PUBLIC UTILITIES COMMISSION

RE : Minor Project Modification #6 for the Riverside Transmission Reliability Project

MINOR PROJECT REFINEMENT REQUEST FORM

MINOR PROJECT REFINEMENT REVIEW FORM

Figure 01 – Modification 01

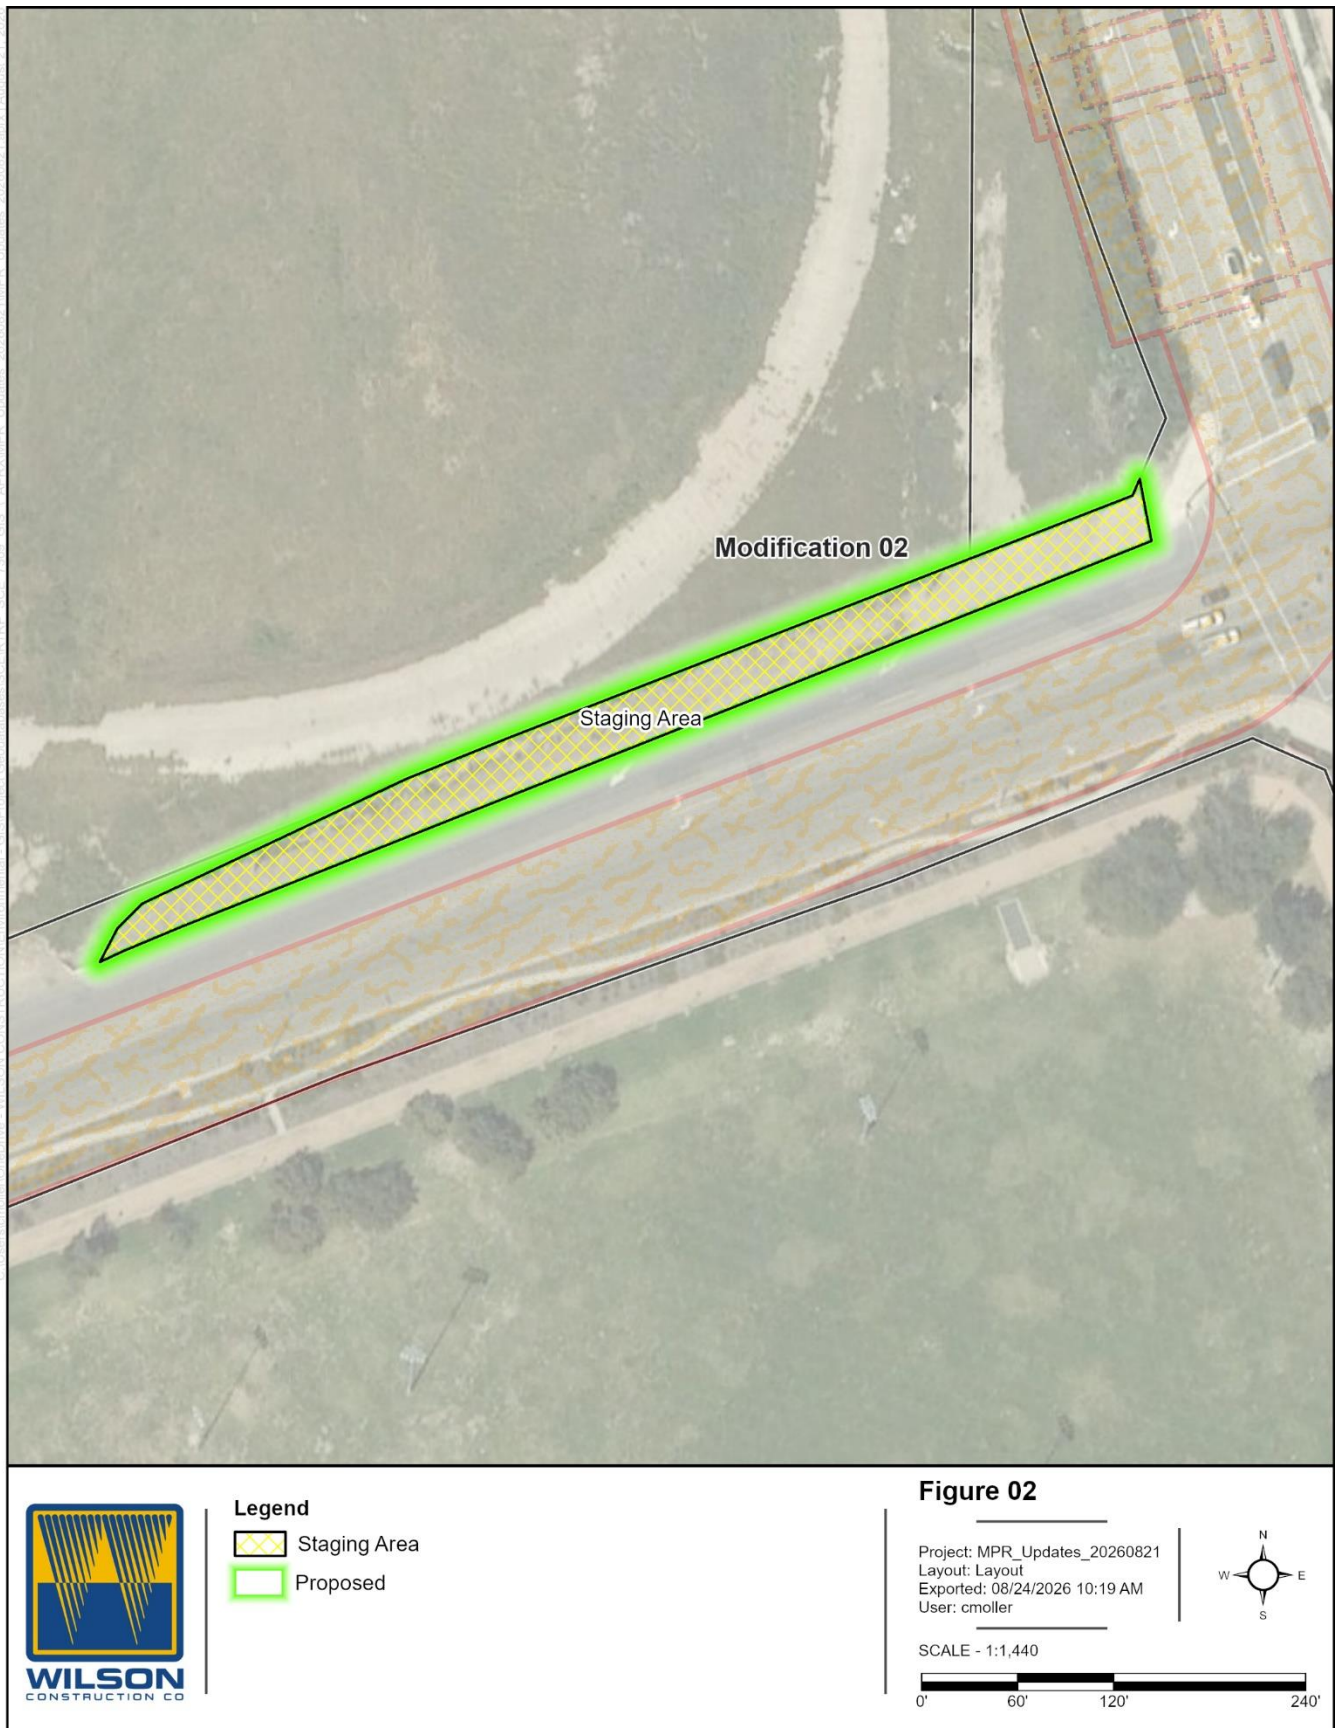
Modification 01 – Wineville Ave. and Bellegrave Ave. – Staging area on dirt shoulder (Figure 01)

- Landowner: City of Jurupa Valley
- Land Use: Open space
- Requesting the use of a previously disturbed shoulder as a staging area for construction materials.
- Existing, disturbed dirt shoulder with no improvements needed.

There is a potential Water of the State located within the boundary of Modification 1. MM BIO-10 requires a wetland delineation to be performed to define the resource and delineate the boundary prior to impacting the potential Water of the State.

Figure 03 – Modification 03

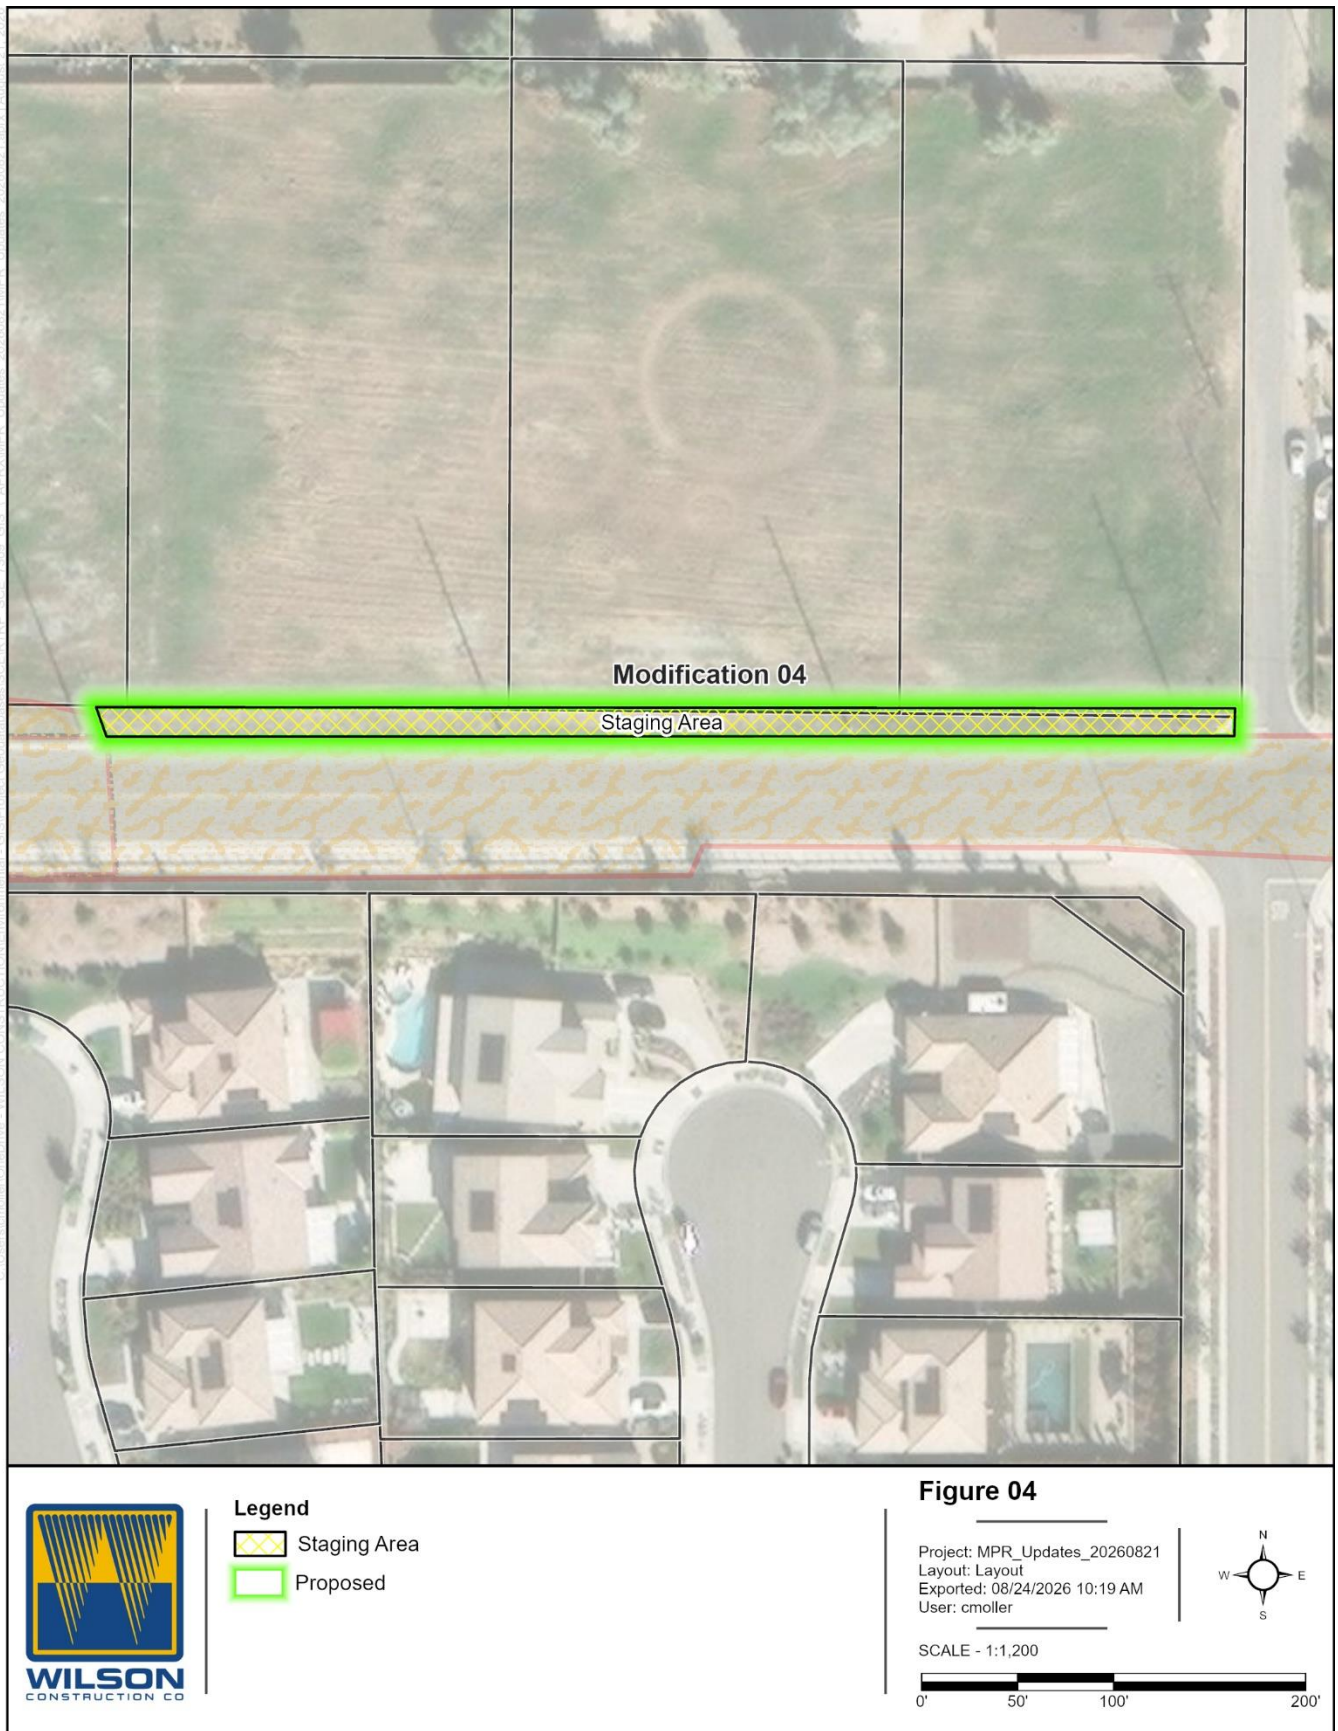
Modification 03 – 68th E/O Holmes Ave. – Staging area on dirt shoulder (Figure 03)

- Landowner: City of Jurupa Valley and Southern California Edison (SCE) easement.
- Land Use: Open space
- Requesting the use of a previously disturbed shoulder as a staging area for construction materials.
- Existing, disturbed dirt shoulder with no improvement needed.
